BEACON PLANNING BOARD
One Municipal Plaza - Courtroom
BEACON, NEW YORK 12508
Phone (845) 838-5002 Fax (845) 838-5026

The Planning Board will meet on **Tuesday, May 8, 2018** in the Municipal Center Courtroom. A work session will take place at 7:00 PM for a training workshop, discussion of agenda items and/or topics of interest to the Planning Board. The regular meeting will begin immediately thereafter, but not later than 7:30 p.m.

City of Beacon Planning Board
5/8/2018

tax id	6054-38-156634
address	38 ST LUKES PLACE
date	04/20/2018
scale	1" = 20'
project no.	18-040
project name	38 ST LUKES PLACE
sheet	1 OF 4

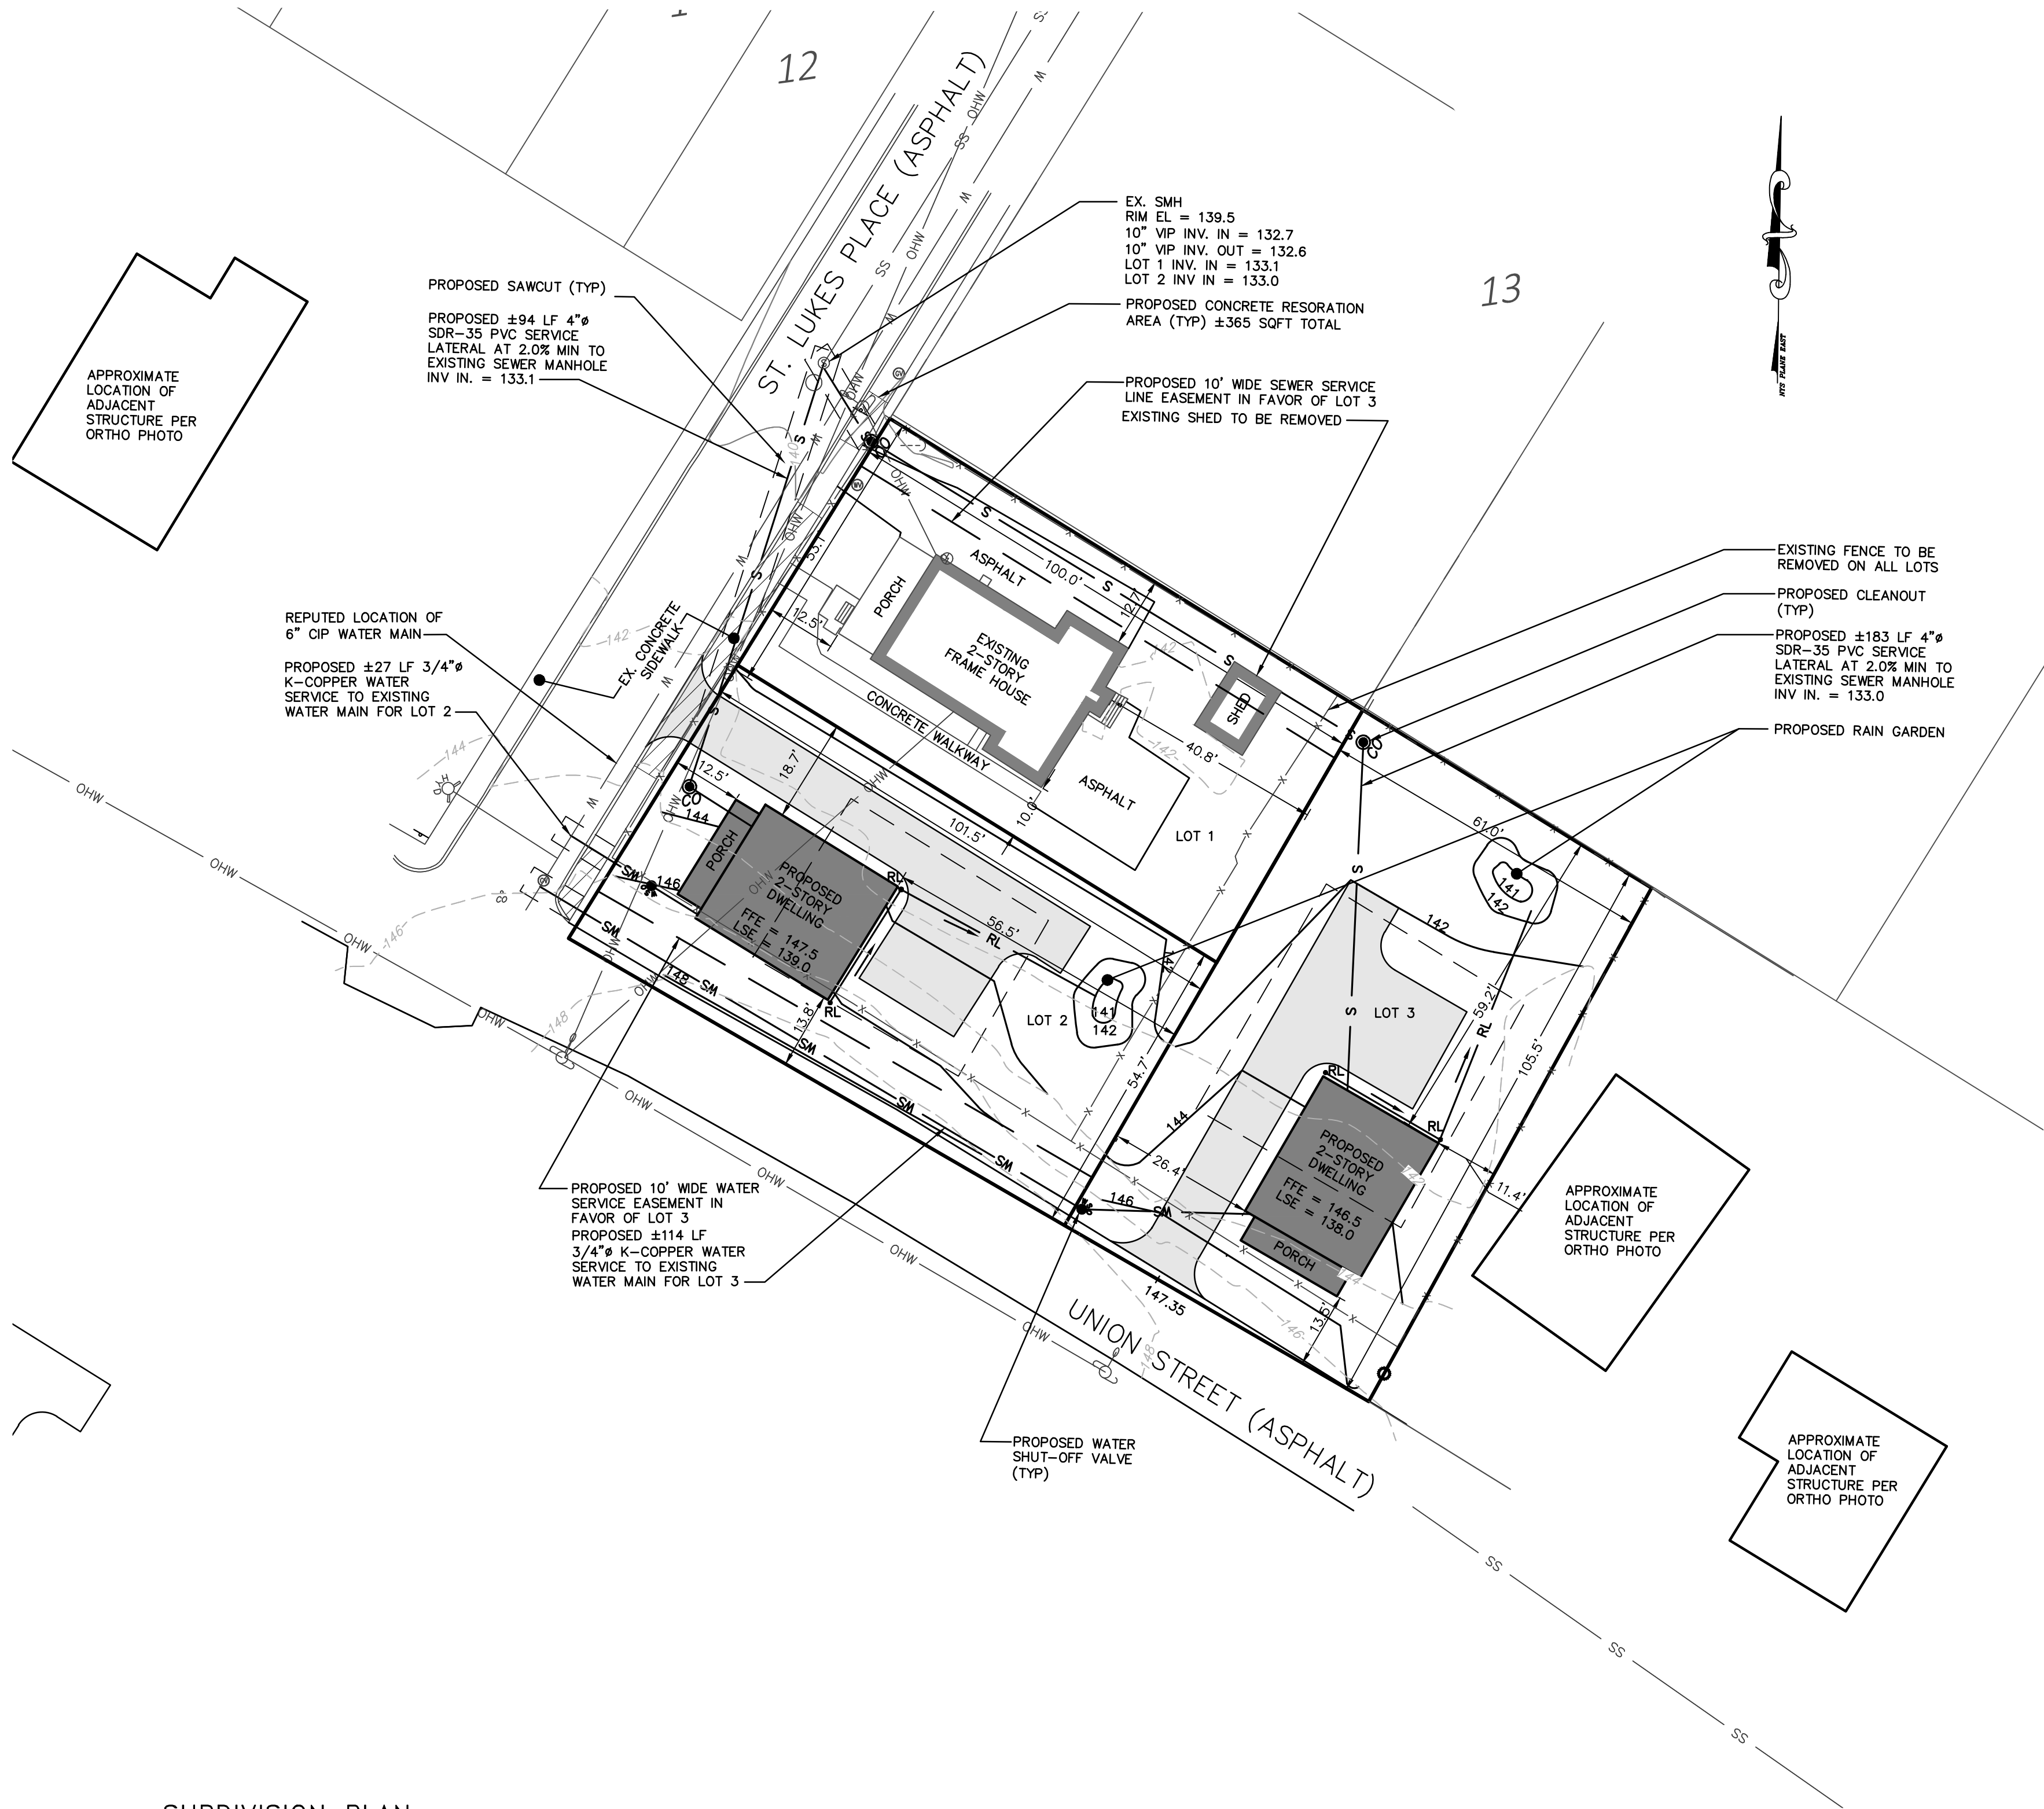
1. The Subdivision Plat should be labeled Preliminary at this point. The survey will need to be stamped and signed before final approval.
2. The Sheet 1 area information should list the parcel size at 0.405 acres to conform with the square footage.

SHEET: 2 OF 4

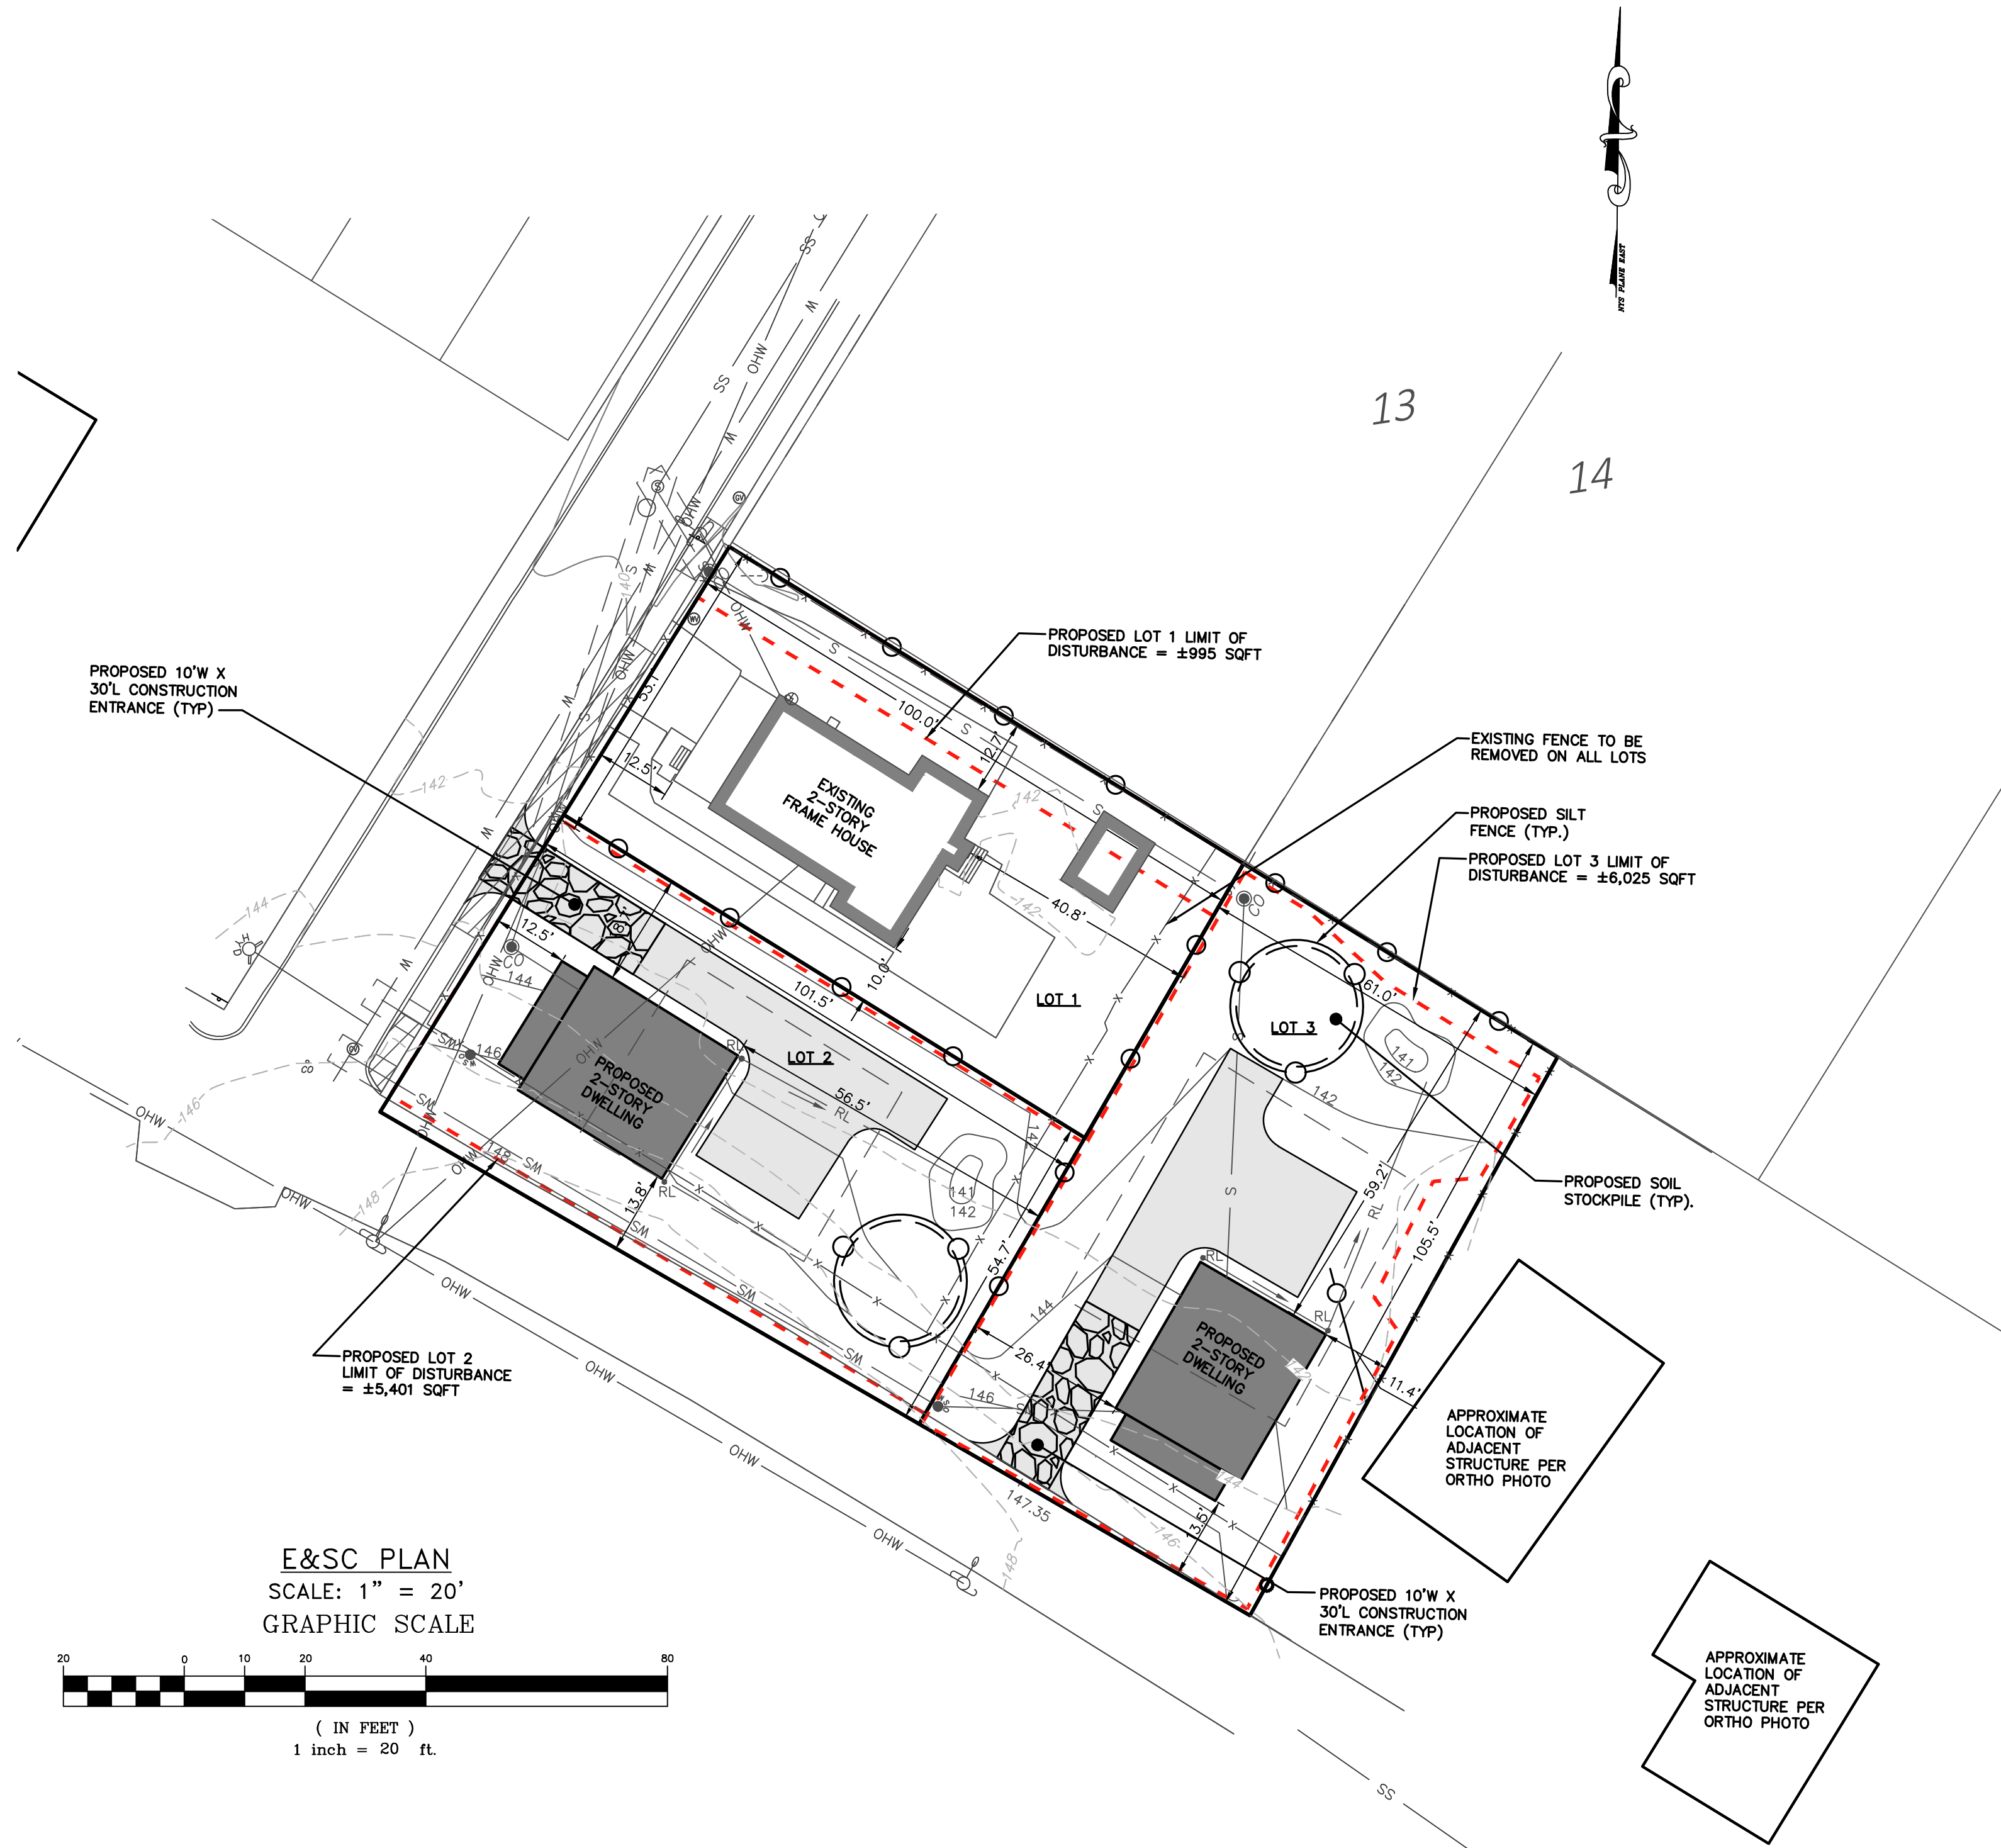
3. The Sheet 2 Project Information list should delete the reference to 0.11 acres.
4. The front setbacks for the new houses are 12.5 - 13.5 feet, less than the required 30 feet, but appropriate given the setbacks of the existing buildings along the adjacent streets. The Board can approve these reduced front setbacks without a variance, under Section 223-13 K.
